# Wire Harness Replacement Kit

Models: Tennant T7 / Nobles Speed Scrub Rider

This kit includes the necessary parts to replace a defective main wire harness on a T7/Speed Scrub Rider. Kit installation is required by TennantTrue® service or an authorized Tennant service provider.

### Controller Board

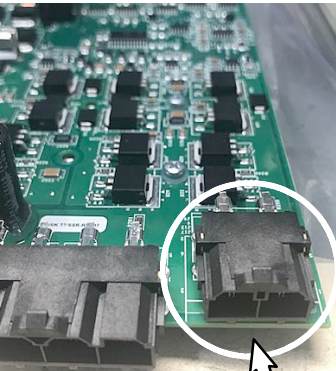
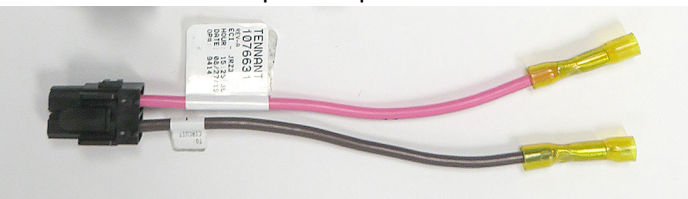
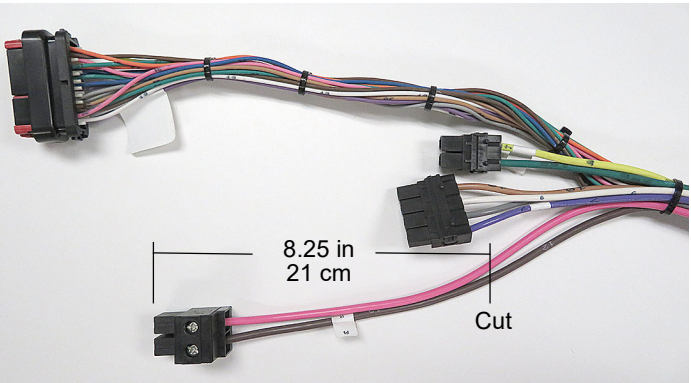
**INSTALLATION NOTICE:** For machines equipped with an old controller board design, shown below, install the supplied connector adapter (p/n 1076631) as described below. The new wire harness is equipped with an upgraded connector design to accommodate the latest controller board design.

\* If the controller board is equipped with the old connector design, shown below, the new wire harness must be reworked with the supplied connector adapter as described in the following instructions.

#### Old Connector Design

#### New Connector Design

Connector Adapter Required

Cut and strip the brown/12 & pink/11 wires. Strip wires 3/8" (9.5 mm)

Connect the supplied harness connector adapter using an insulated terminal crimping tool. Seal the terminal connectors with a heat gun.
